TOWN OF BAY HARBOR ISLANDS

SPECIAL COUNCIL MEETING AGENDA

June 29, 2022 – Approximately 7:00 P.M.

ITEM: Consideration and Approval of an application for an appeal to the Town Council of the Town of Bay Harbor Islands, Florida of a June 7th, 2022 decision of the Design Review Board, denying an application by Bay Harbor Islands Property Owner II, LLC for Site Development Plan Modification pertaining to development at 9431, 9461, and 9481 East Bay Harbor Drive, Bay Harbor Islands, Florida. Enclosed are supporting documents.

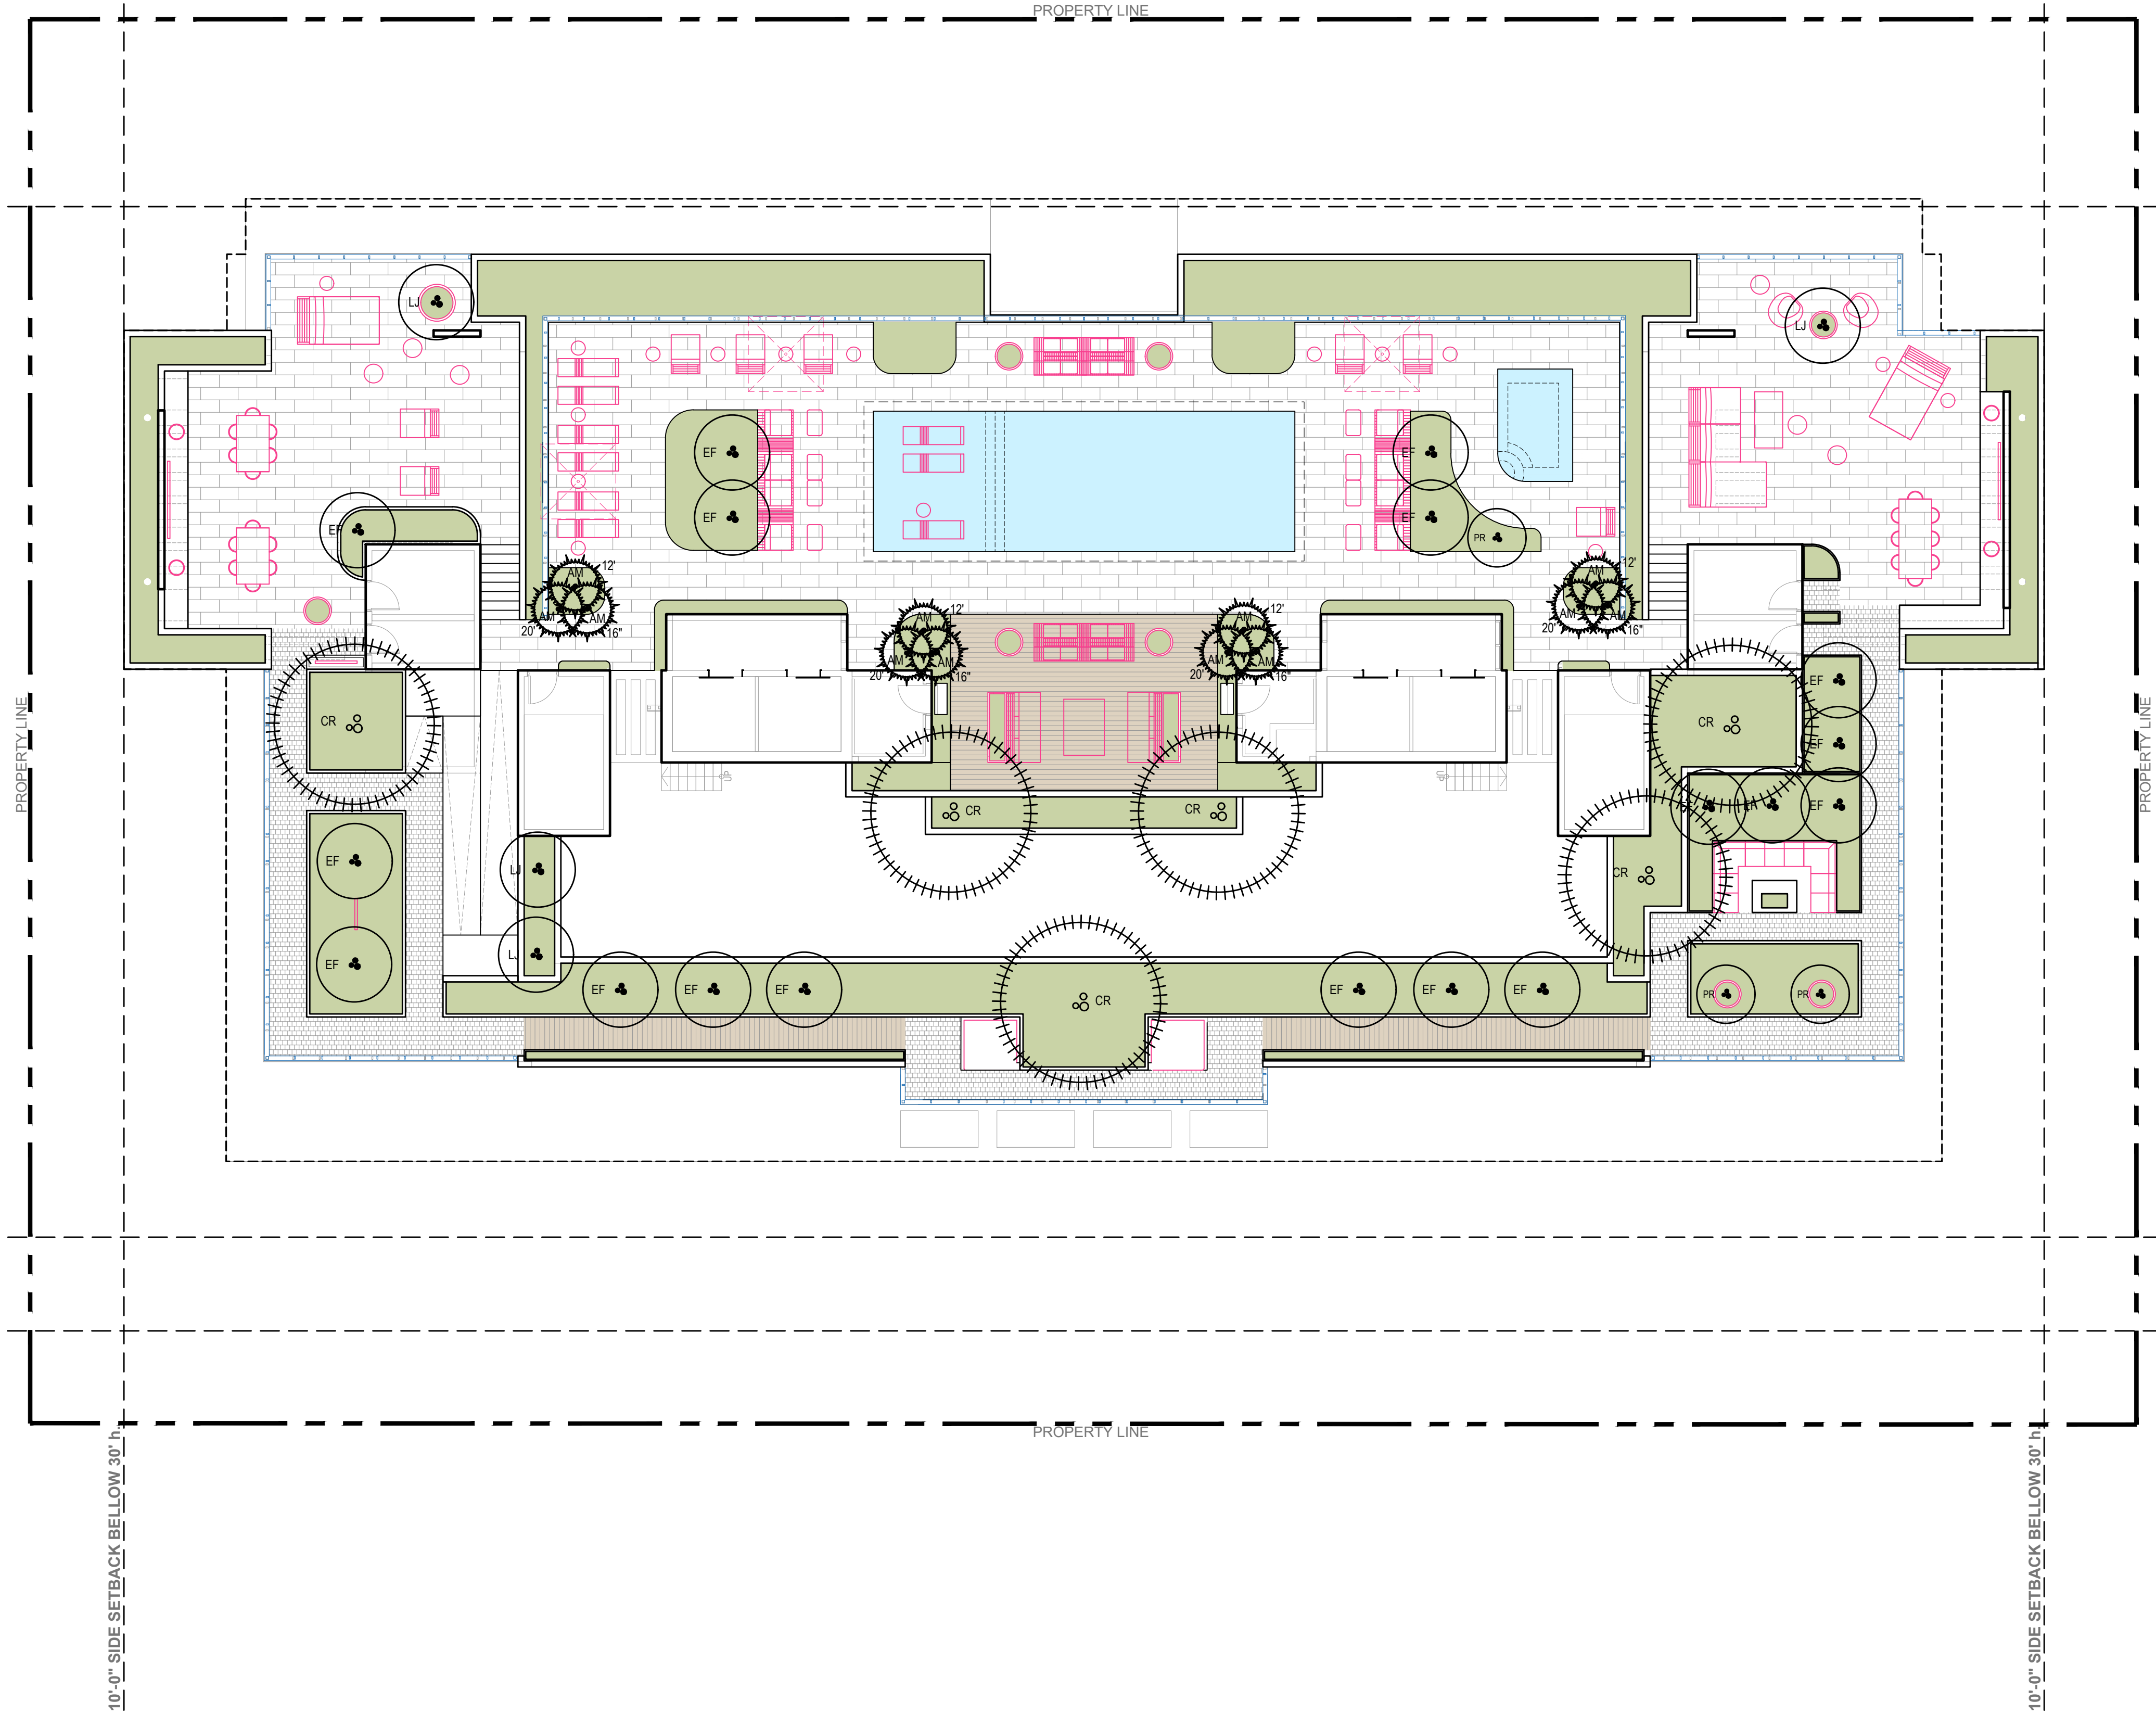
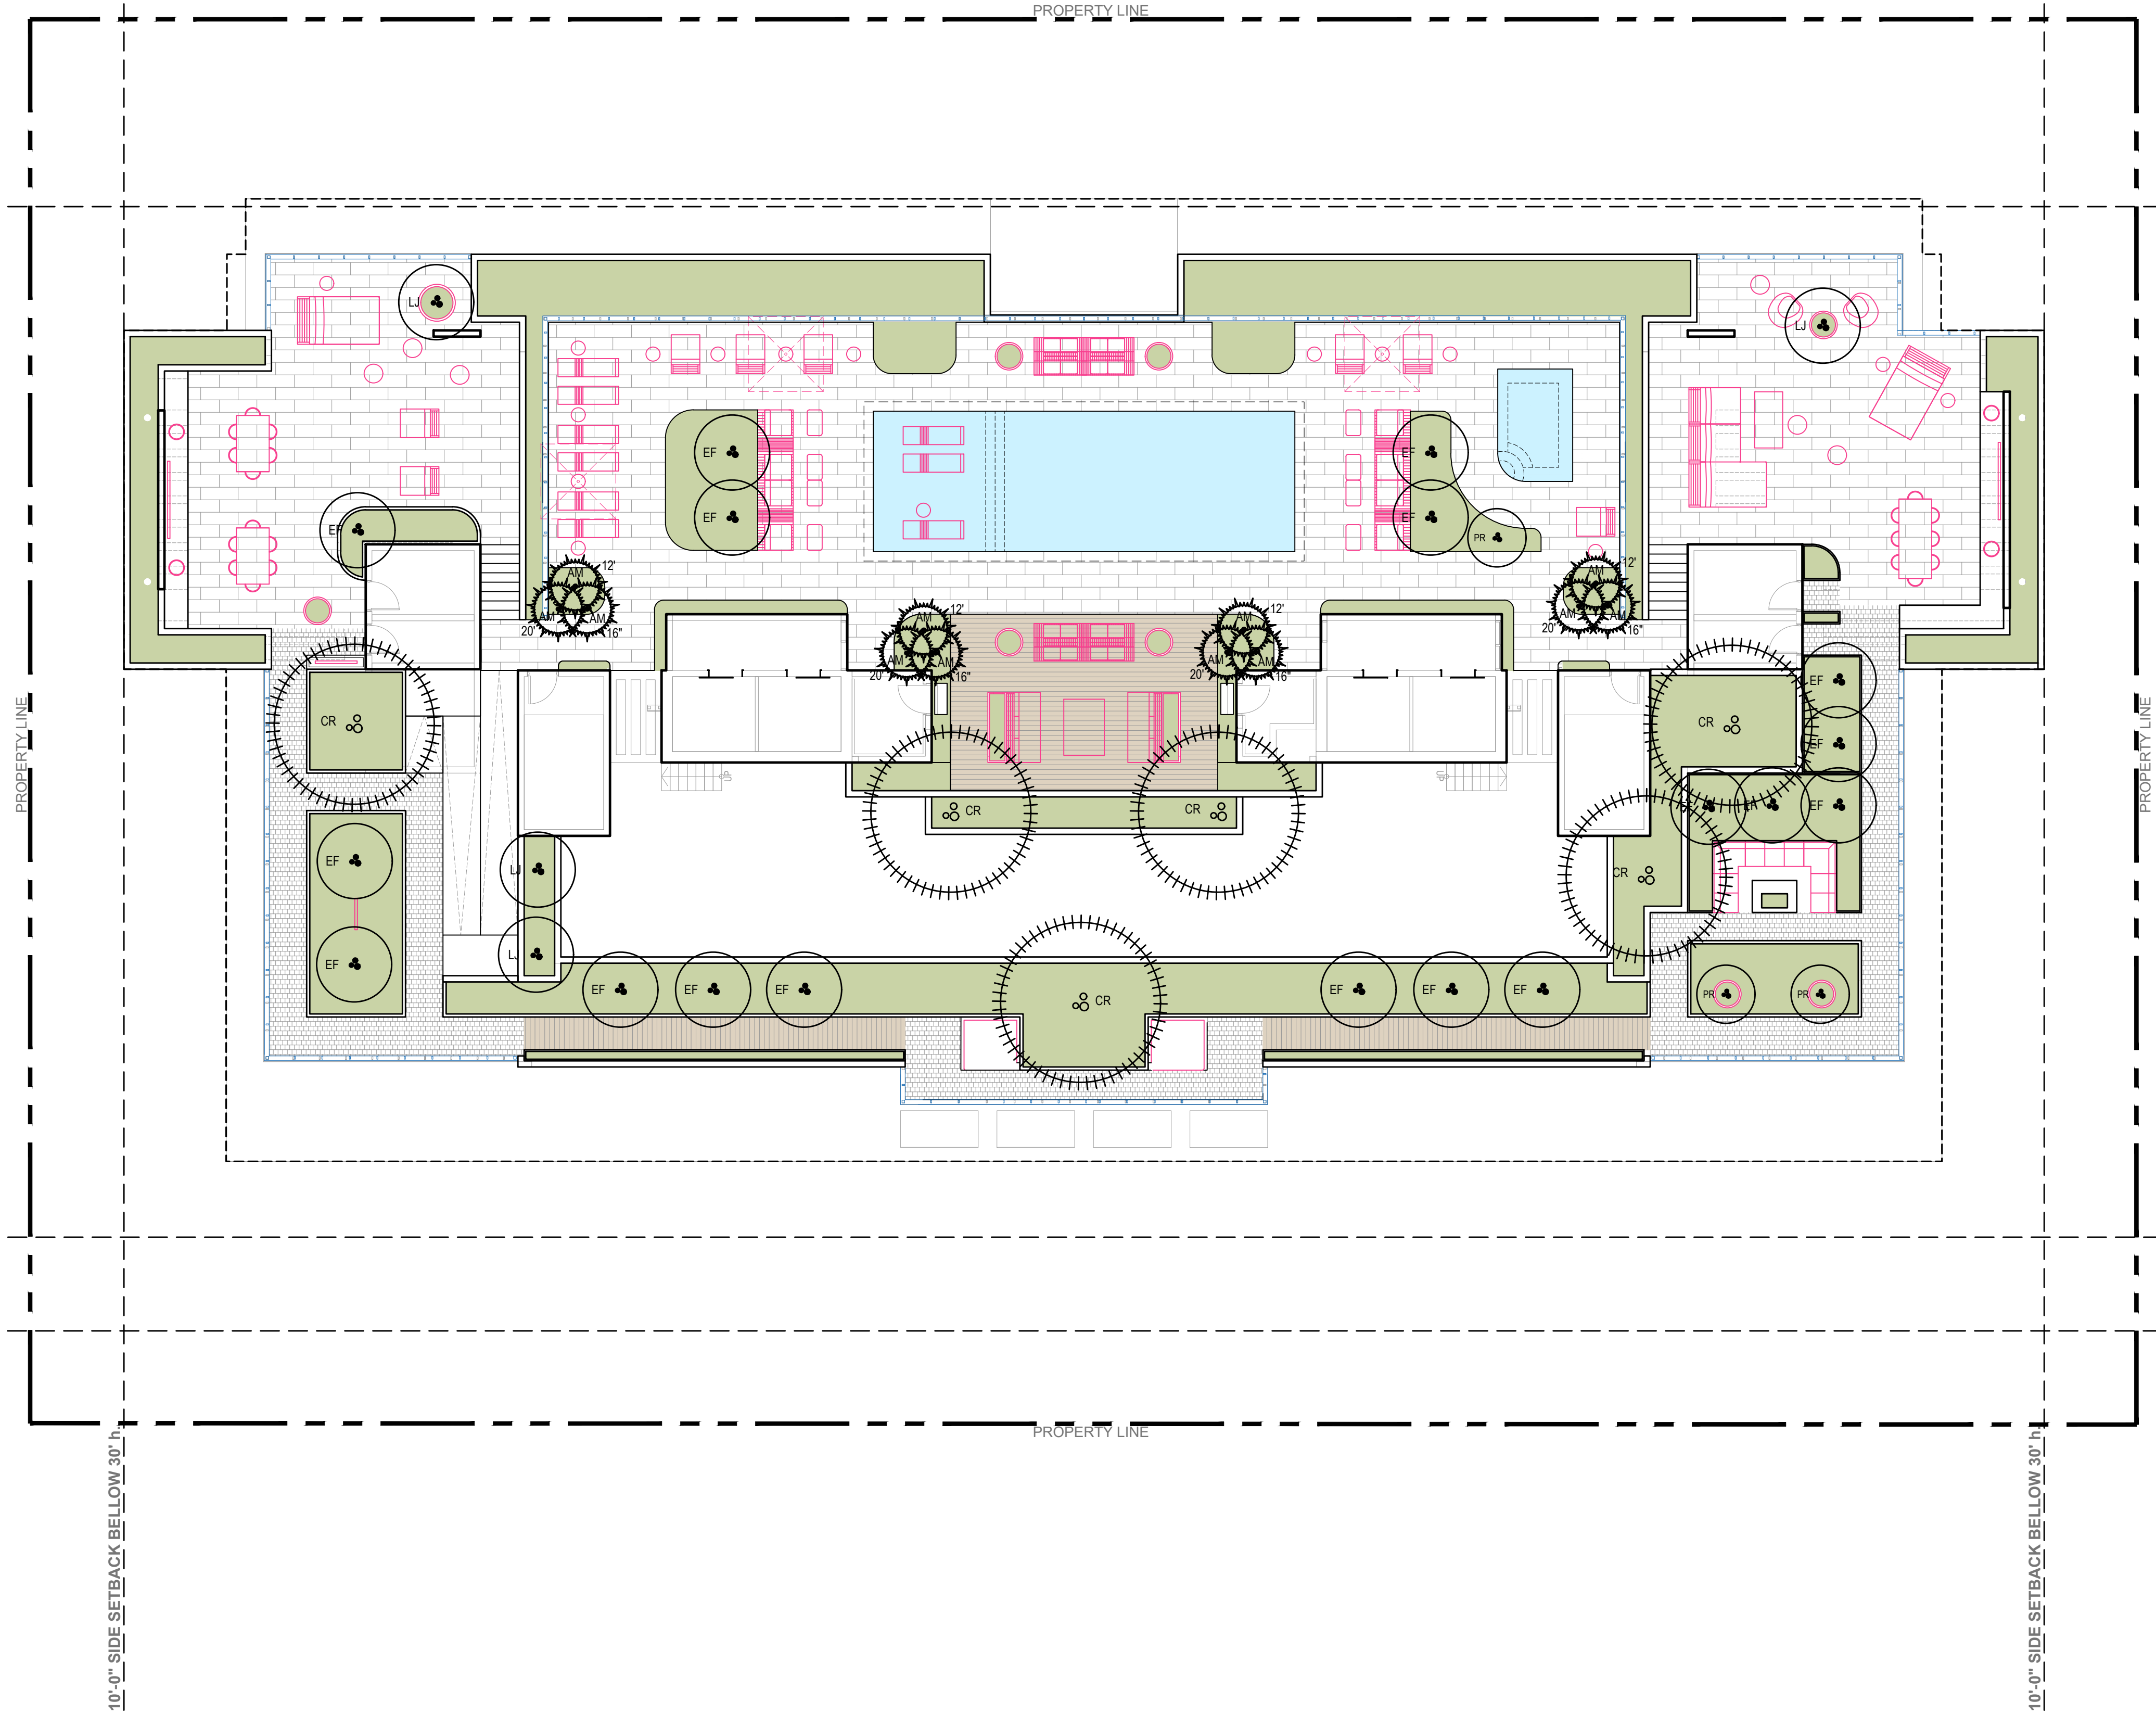
o Landscape Material Sizes - On Sheet L-103 a plant list is provided showing the specifications for trees / shrubs / etc. In South Florida (M-D / Broward / etc.) all landscape materials are specified in Landscape Codes by height / spread / trunk caliper m- not a container size. You could have a 50-gallon container with the 3' height tree - everyone understands it is a landscape nursery / industry term but is not reliable for ensuring properly sized plant materials are installed. Most of the trees listed in the table have hgt. / spread / caliper space - but not the shrubs. The Town Code requires shrubs to be at least 24" tall / 24" on center at time of planting. Revise the plans.

CRS response – Understood and updated per sheet L-103. Spacing shown in plan on sheet L-102
